GULF STATES UTILITIES COMPANY

June 3, 1985
RBG- 21199
File No. G9.5,
G9.8.6.2

River Bend Station-Unit 1
Docket No. 50-458

ATTACHMENT 1

FIGURE 1
IMPACT LOAD

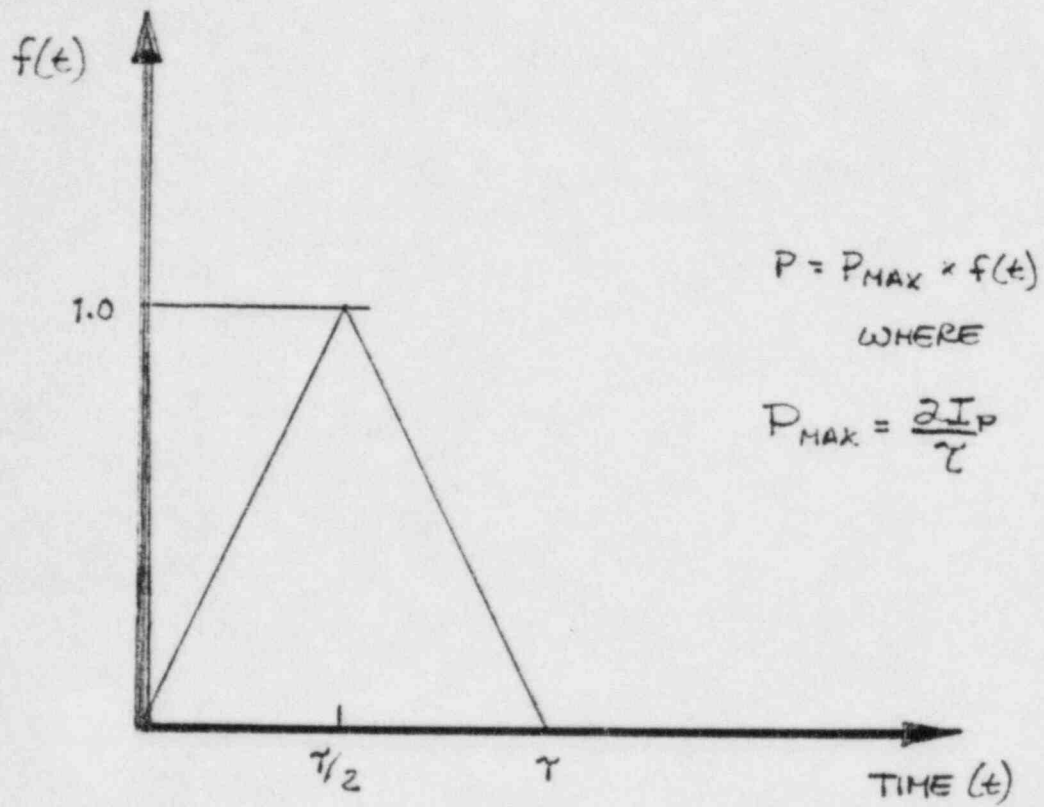
7. Apply the impact load as a triangular impulse with the peak pressure and pulse duration determined in Step 6 and Step 5, respectively (see attached Figure 1).
